Addendum No. 1

Project: Village on the Preserve – Phase 2
For: Lanoha Development

Date: 1 February 2012
 From: Studio 951, Ltd.
 To: All plan holders.

E2.01-4

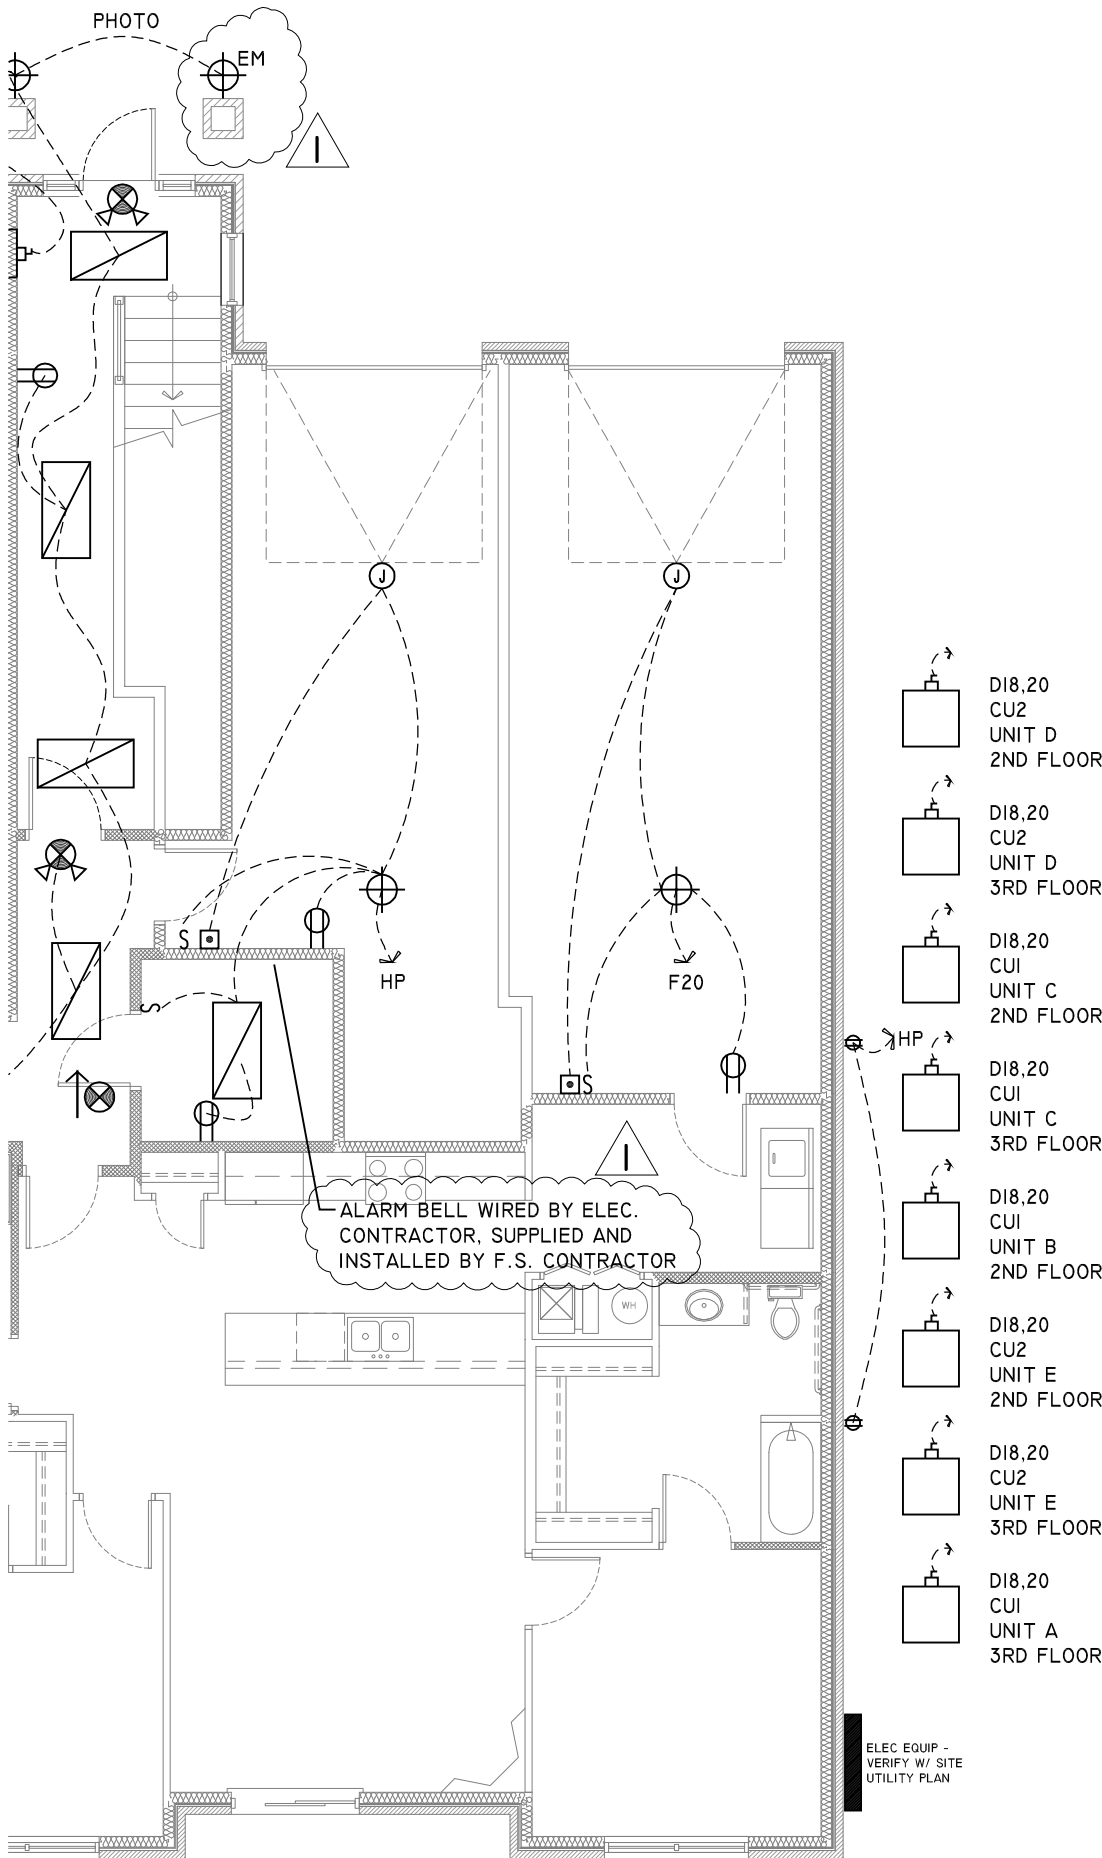
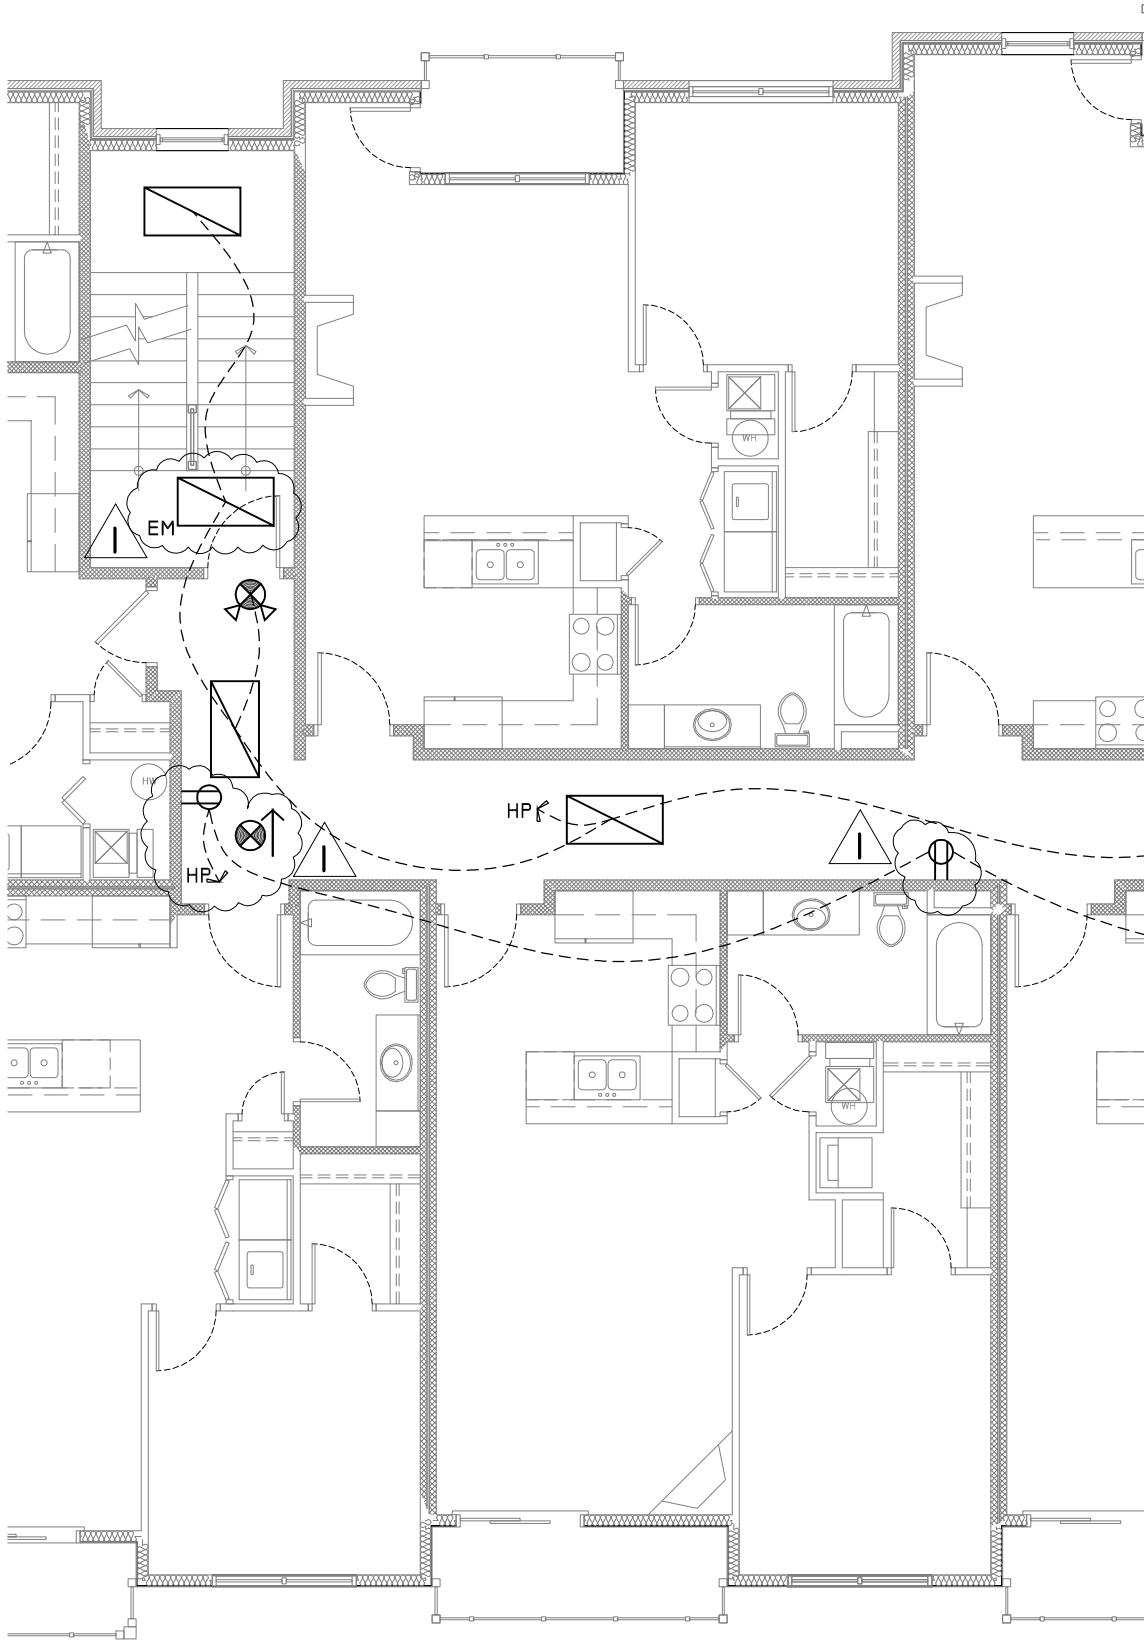
See E2.01-2, E2.01-3, E2.01-4 showing revision to the Main Floor Electrical Plan.

E2.02-1

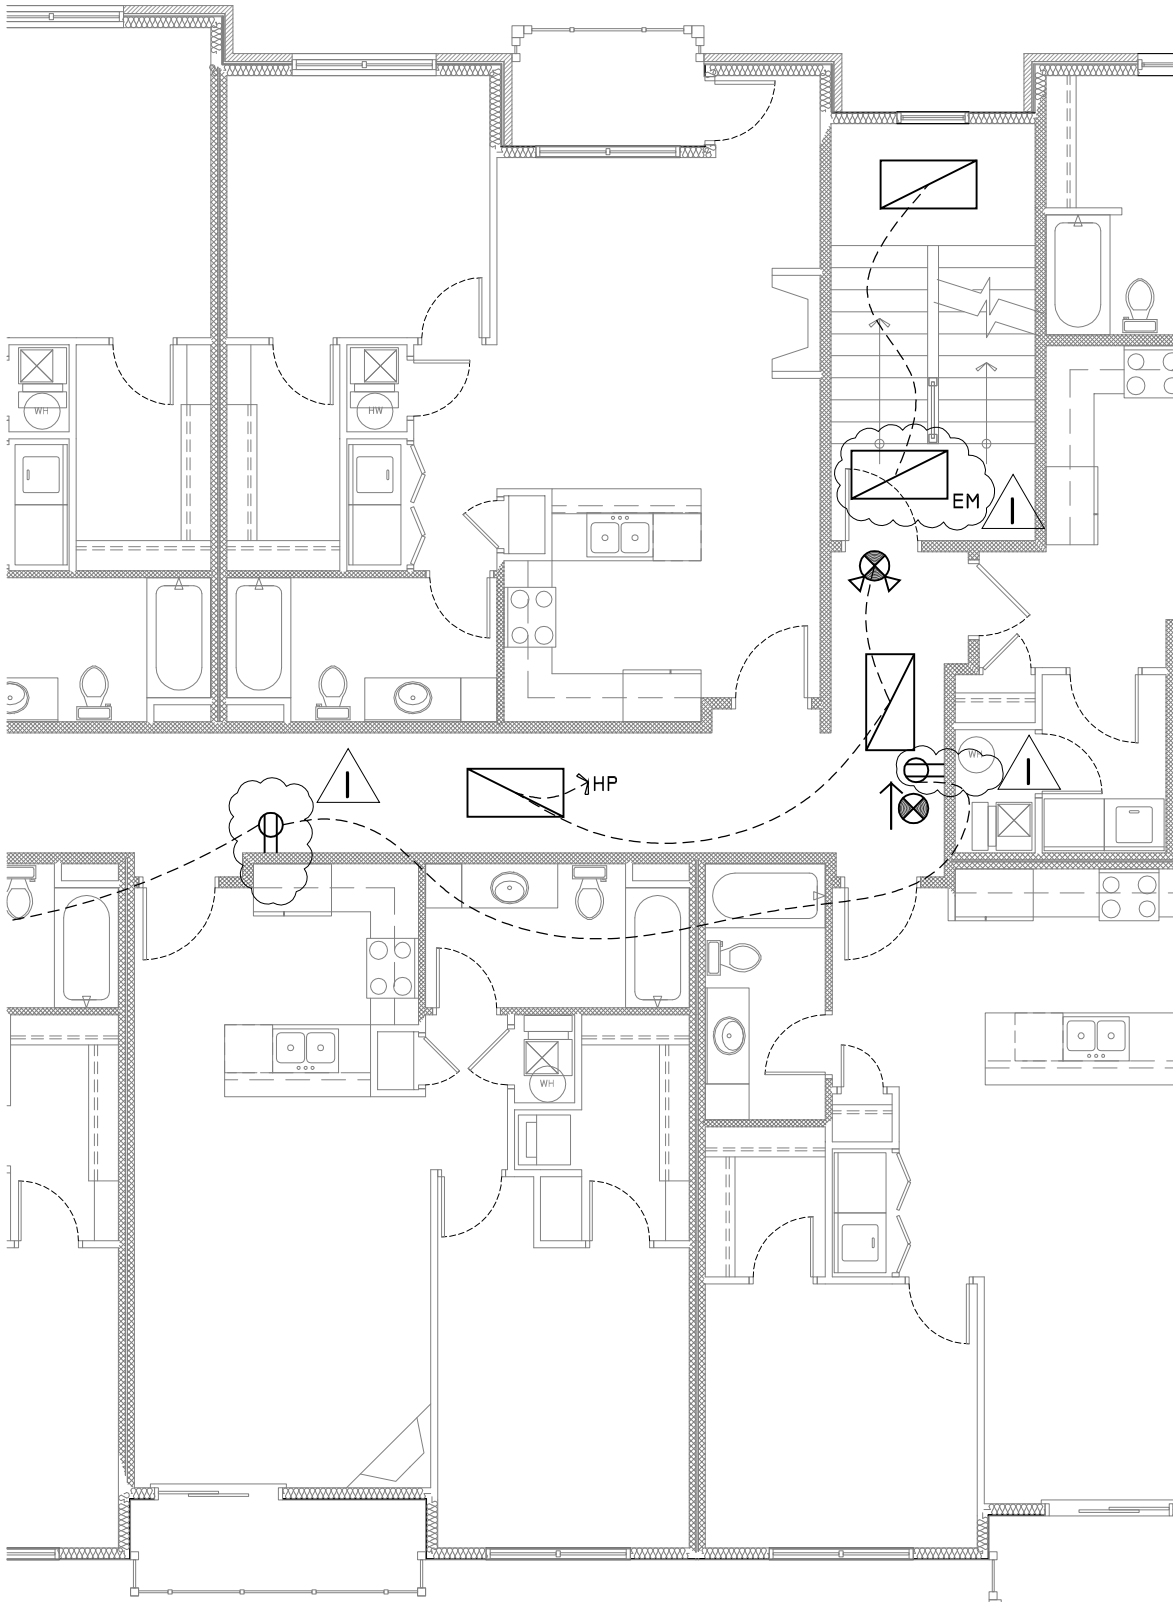
See E2.02-1, E2.02-2 for revised information.

E2.03-1

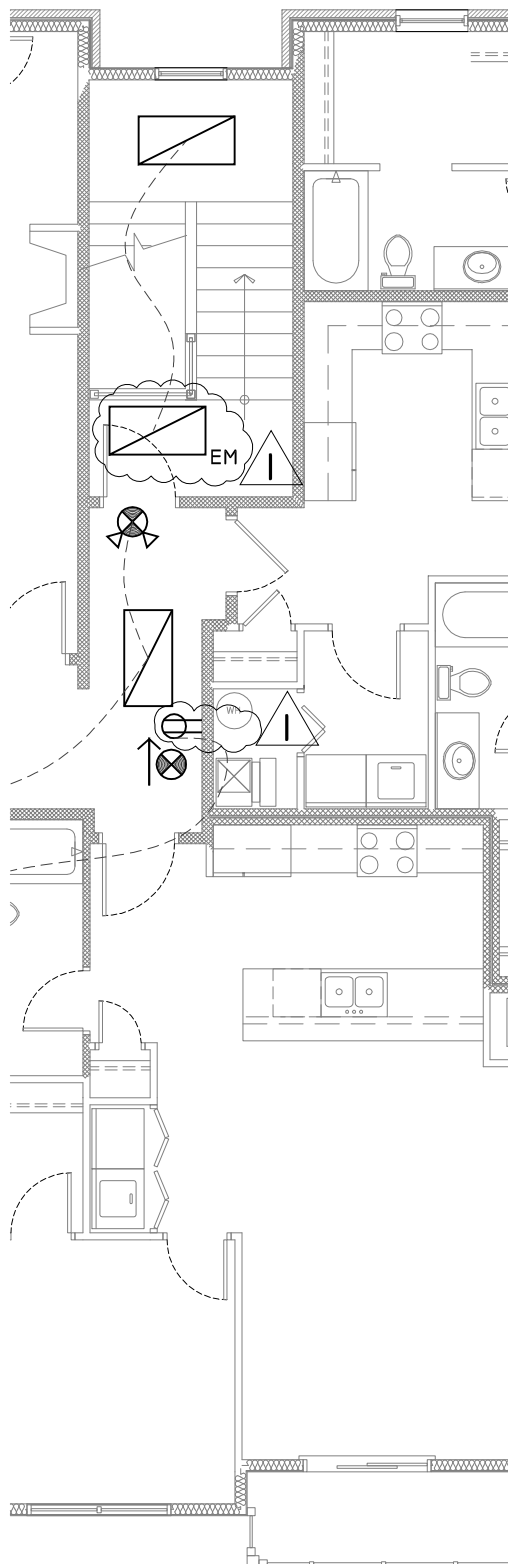
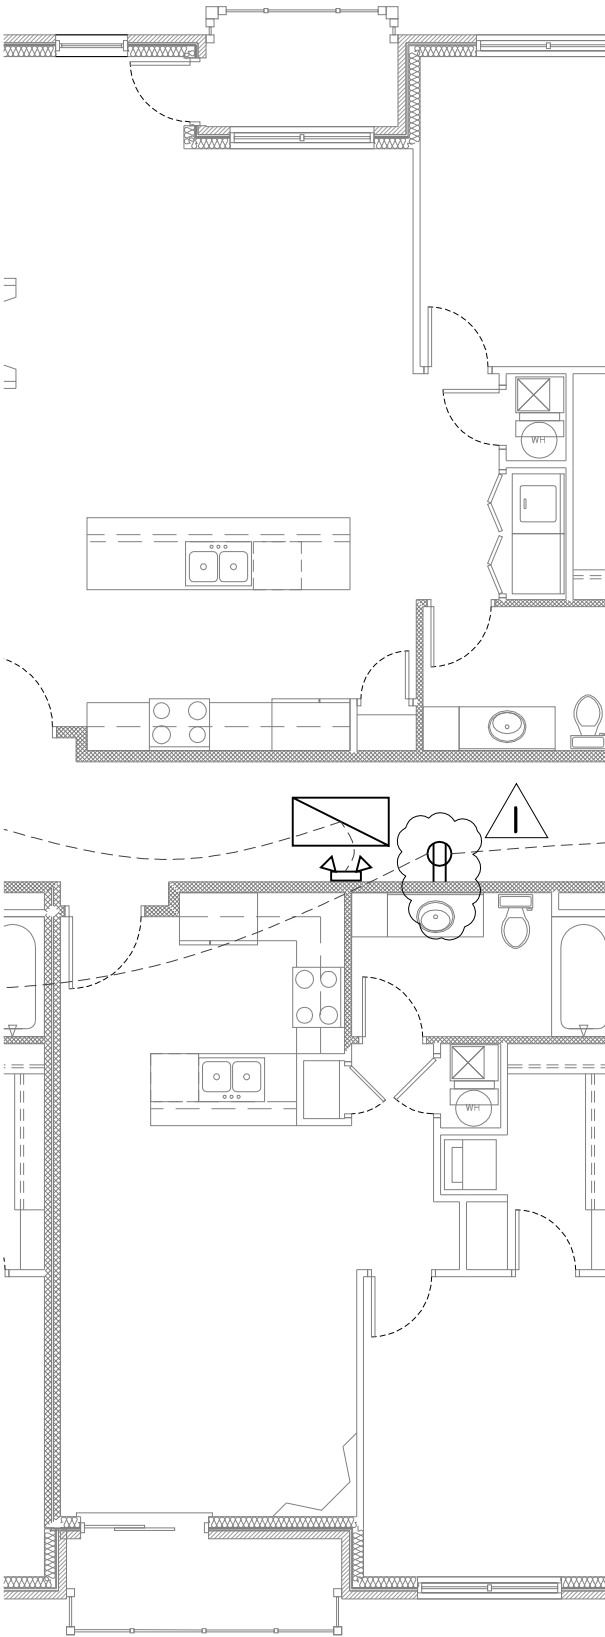
See E2.03-1, E2.02-3 for revised information.

E2.04-1

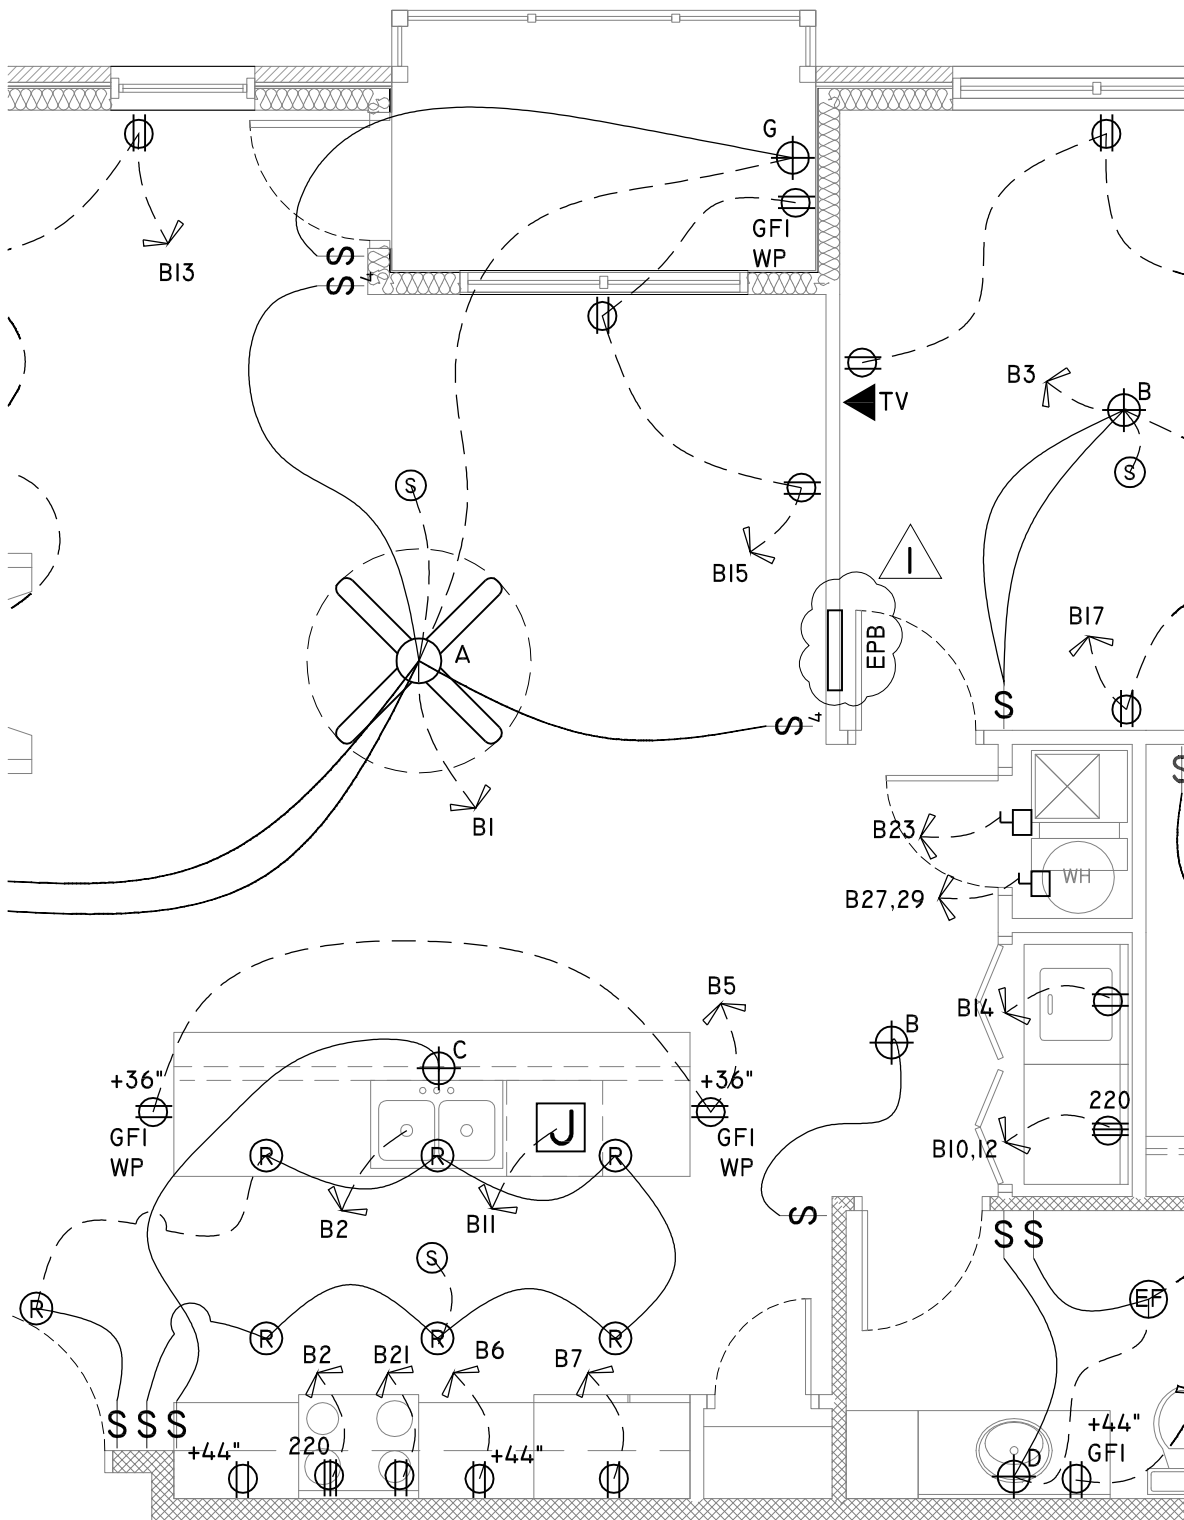
See E2.04-1, E2.04-2, E2.04-3, E2.04-4, E2.04-5, E2.04-6, E2.04-7

Please add a note to each sheet to read, "Cable TV outlet box and wiring by Others. Location shown for reference only."
